BERRYVILLE AREA DEVELOPMENT AUTHORITY

AGENDA

Modifications to the approved site plan for the assisted living facility located at 450 Mosby have been received from the applicant. The site plan, included in this packet, identify changes that have been completed (utility) and those proposed. Below is a synopsis of the changes:

CONNECTION SENIOR LIVING
 SANITARY SEWER PROFILES & STORM SEWER COLDS
 SITE PLAN
 TOWN OF BERRYVILLE, VIRGINIA

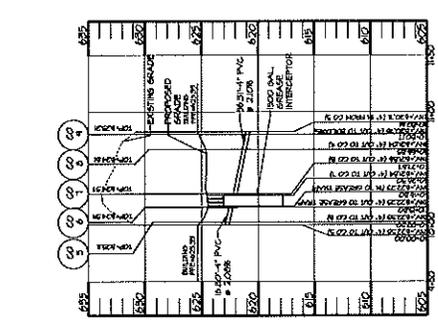
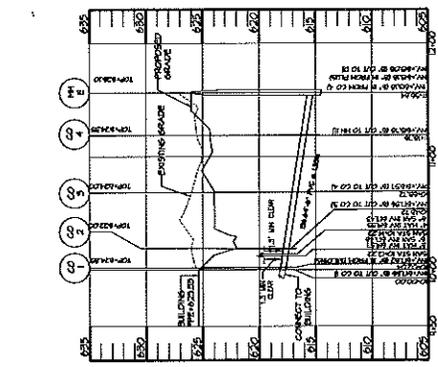
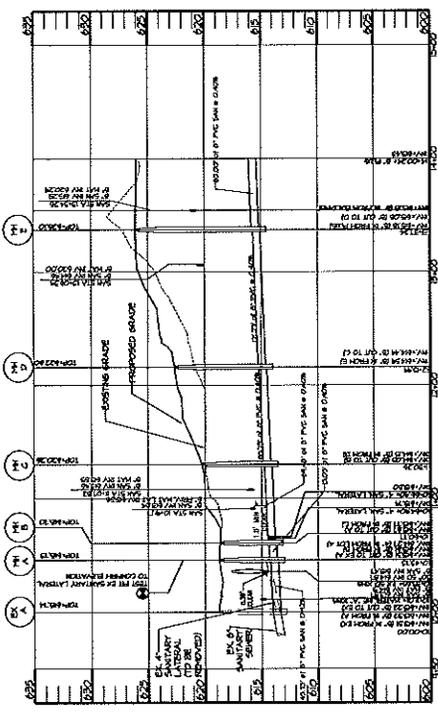
2. Water and sewer modifications were made on site after consultation with the Town's engineer and public works staff. Changes include the addition of a private 4" sanitary sewer lateral and grease trap at the rear of the building; private waterline changes including the increase of the fire line to 8"; an increase in the size of the domestic water line to 4"; and an increase in the meter vault to 2" in order to enable a larger meter should water demands be higher than anticipated. Please note that should the meter be increased in size, additional water and sewer availability fees will be required.

OVERALL SWM PRE-DEVELOPED DRAINAGE MAP
 CONNECTION SENIOR LIVING
 SITE PLAN
 TOWN OF BERRYVILLE, VIRGINIA

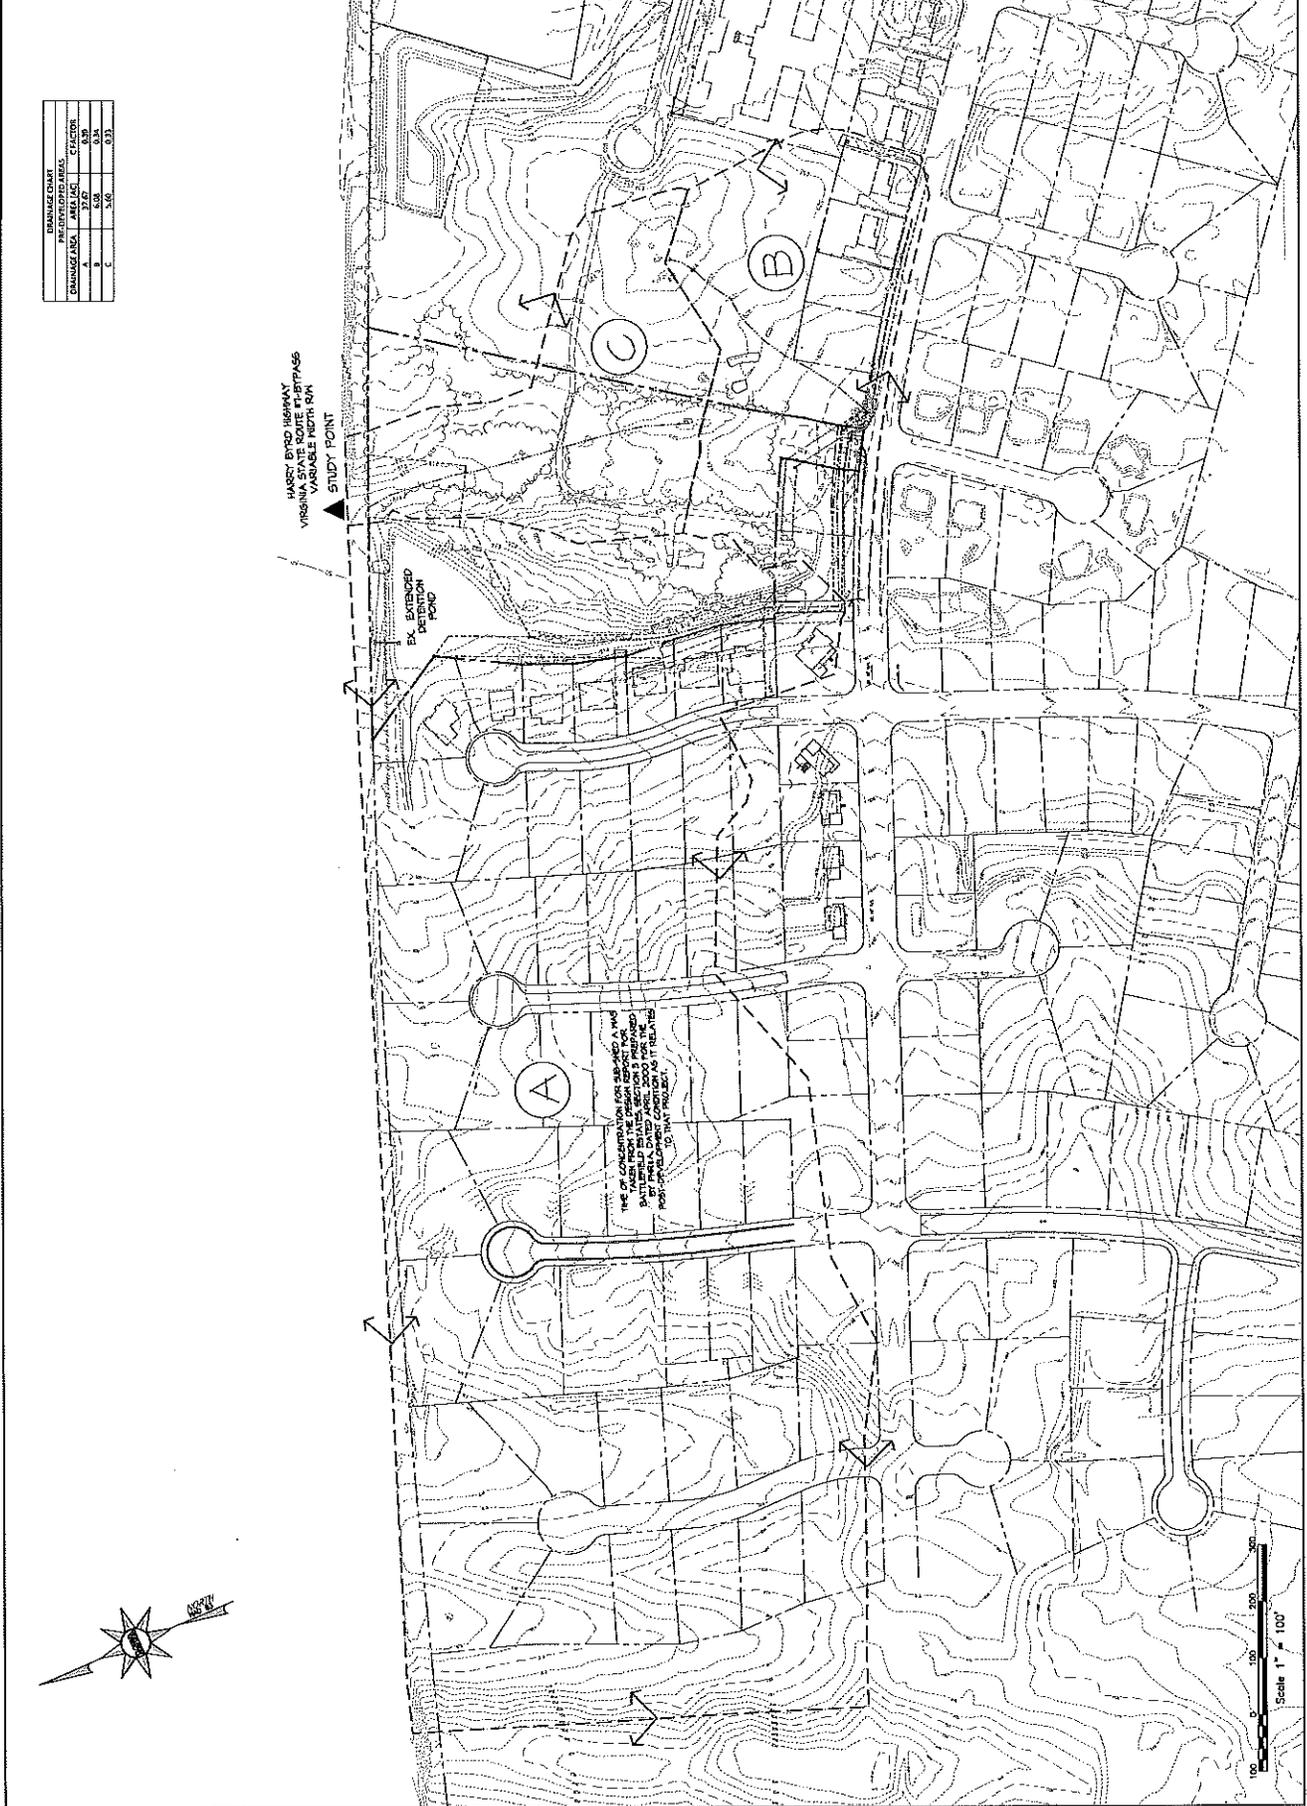
3. DEQ has approved the applicant's request to not make improvements to the existing stormwater management facility located on the northwest side of the parcel. Nutrient credits will be purchased which will nullify the need for water quality requirements. A new stormwater management facility, (identified as SWM Pond #1), proposed for the east side of the existing storm pond, will capture runoff from the majority of the development and will meet water quantity requirements. Small bioretention facilities have been removed from the updated plans and storm pipes have been redesigned to handle the increased runoff from the building. Mr. Erickson will discuss the purchase of nutrient credits and answer any questions Authority members may have.

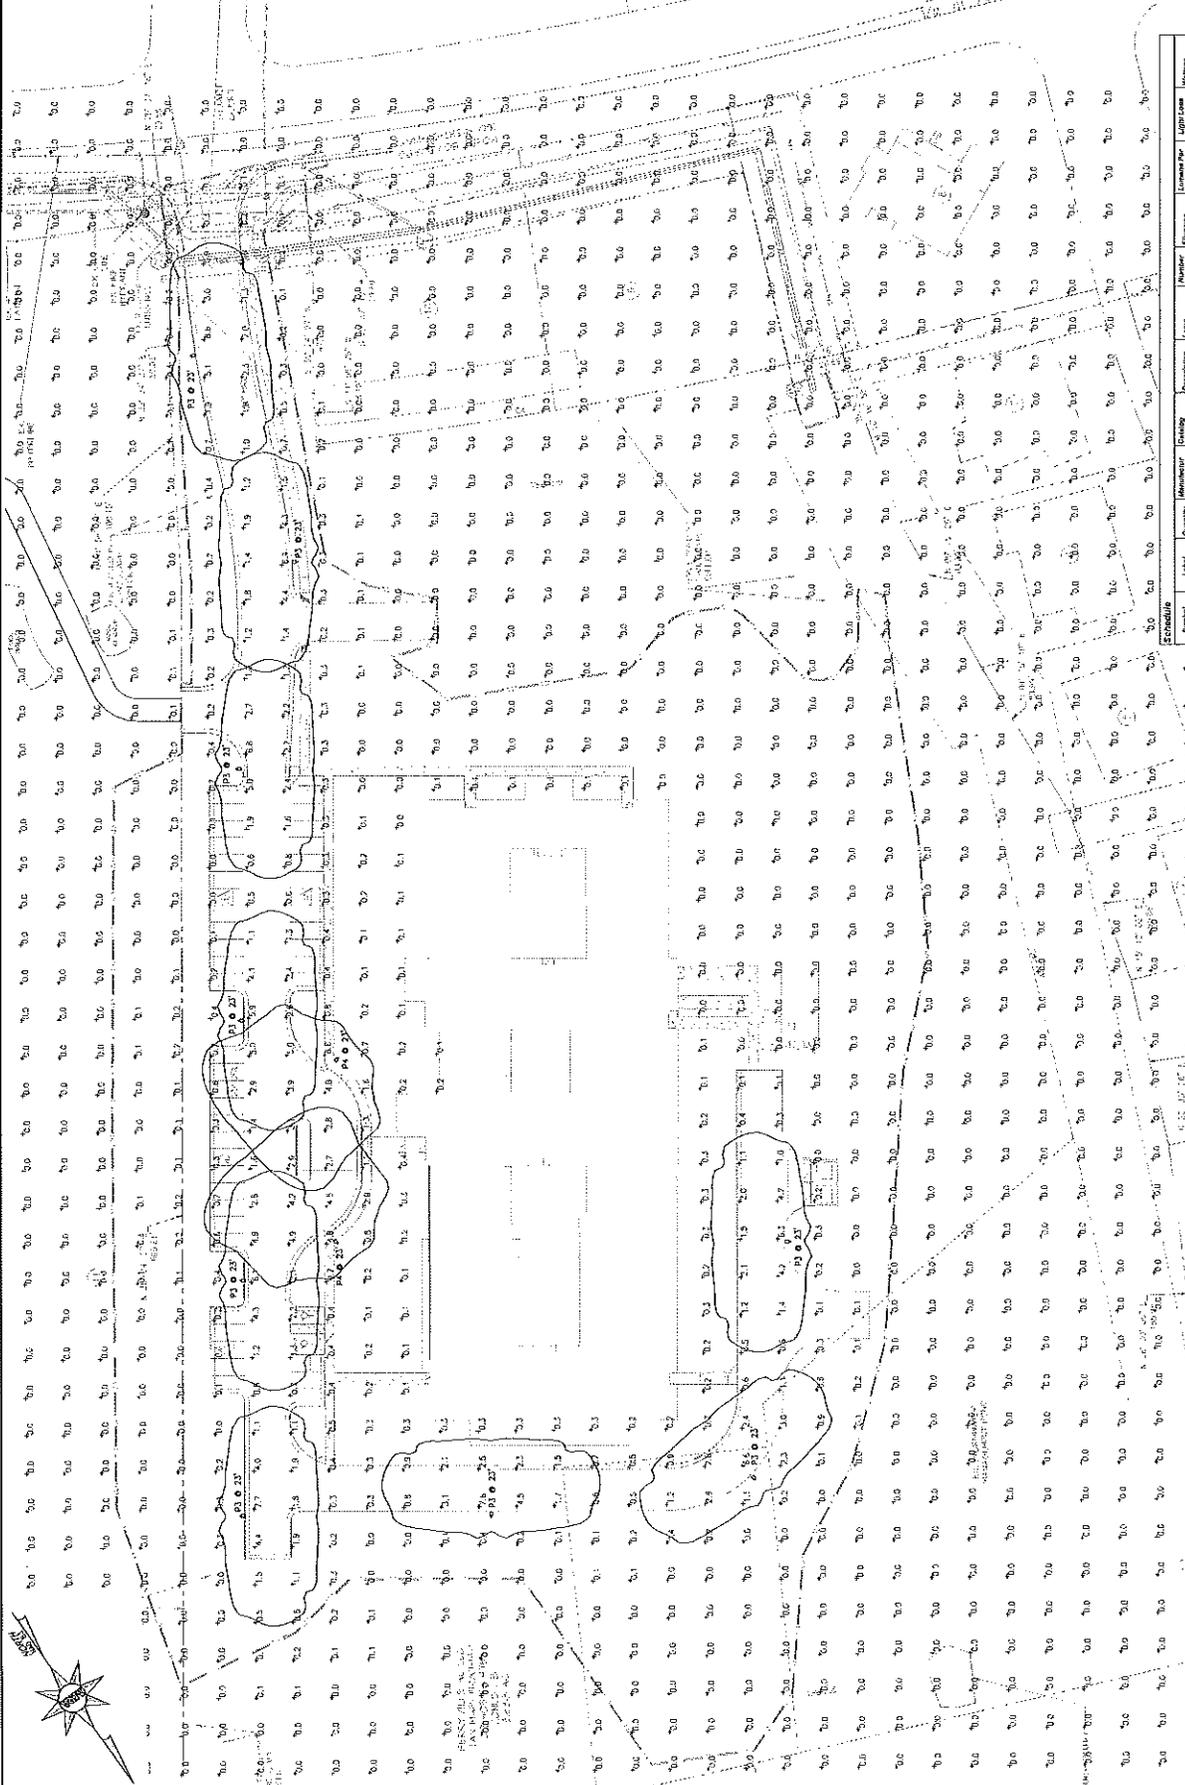
4. A fire lane has been added south of the access drive and an emergency access easement has been included.
5. An extension of the loading area is identified on the plans at the rear of the building. Lighting has been modified to be at ground level rather than on poles. Mr. Erickson will be discussing the lighting at the meeting.

EXTERIOR MONUMENT SIGN DETAILS
THE RETREAT AT BERRYVILLE

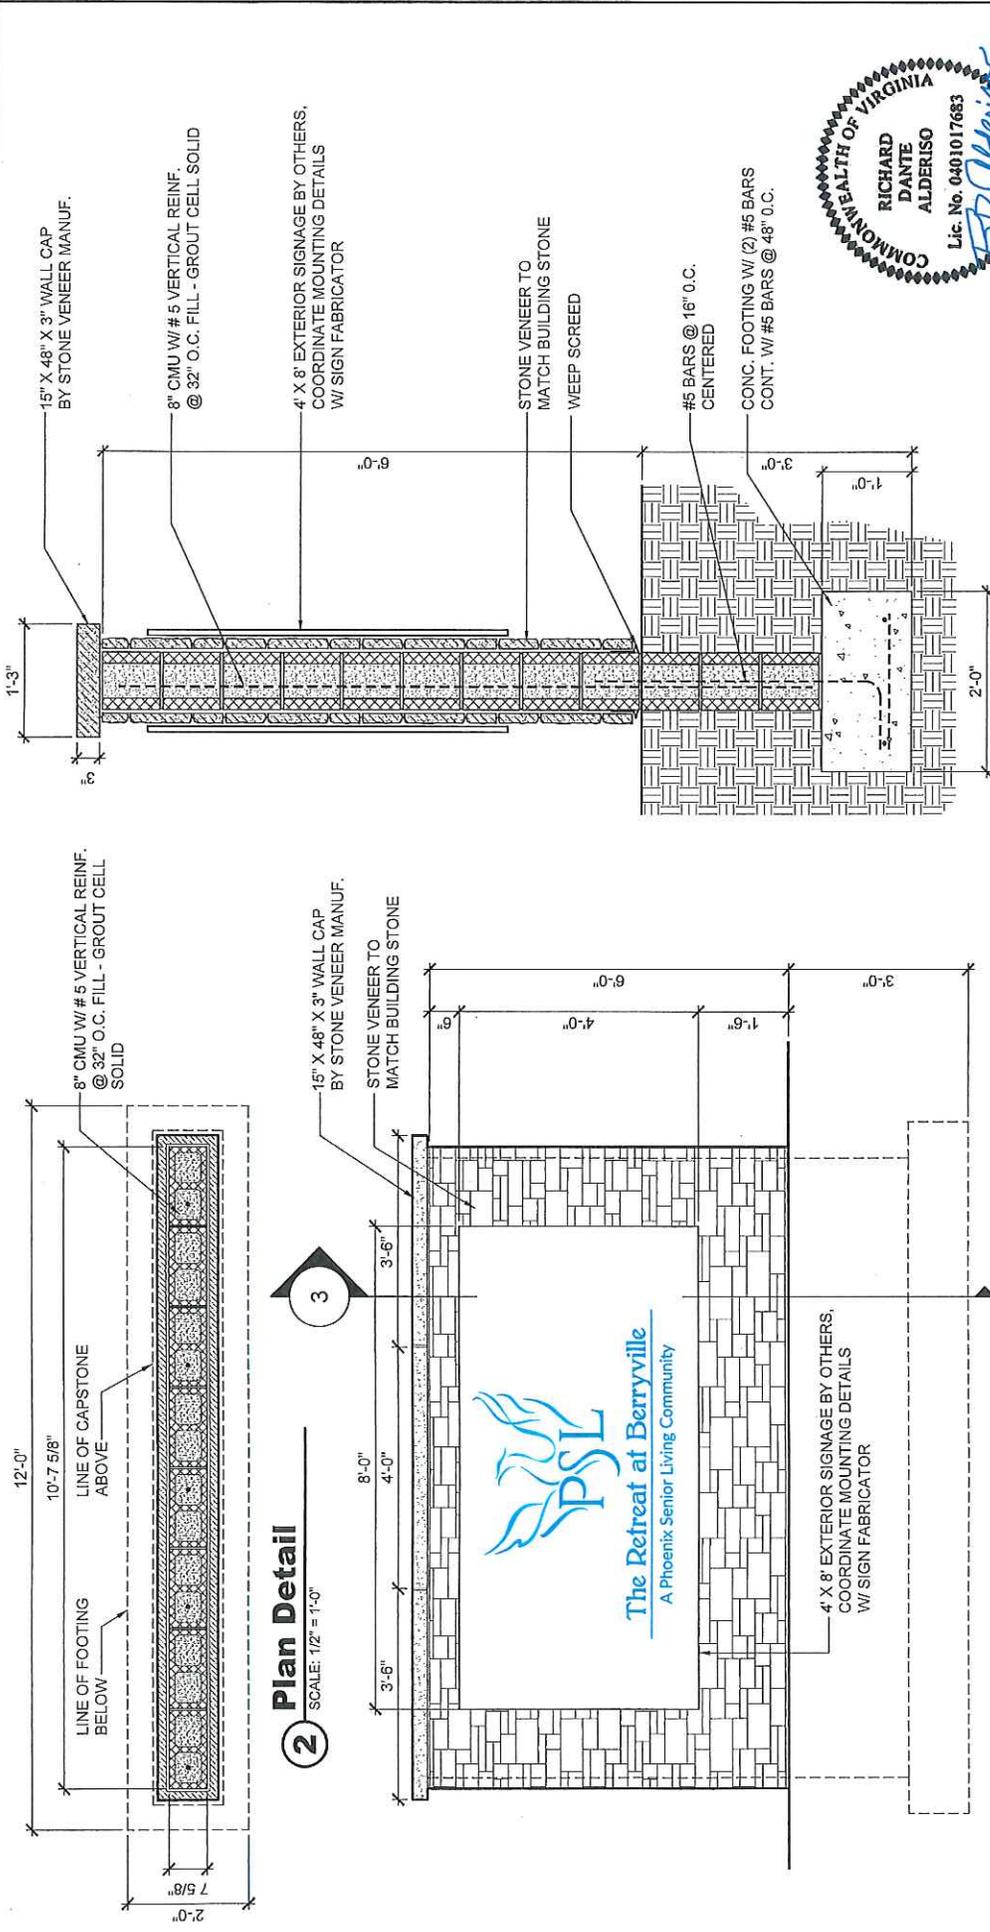
6. A monument sign is proposed for the front of the parcel. Please note that the sign included in the packet is larger than permitted in Section 307 Sign Regulations, of the Berryville Zoning Ordinance. Staff has discussed the matter with the project manager and developer who will submit a modified drawing which conforms to these regulations.
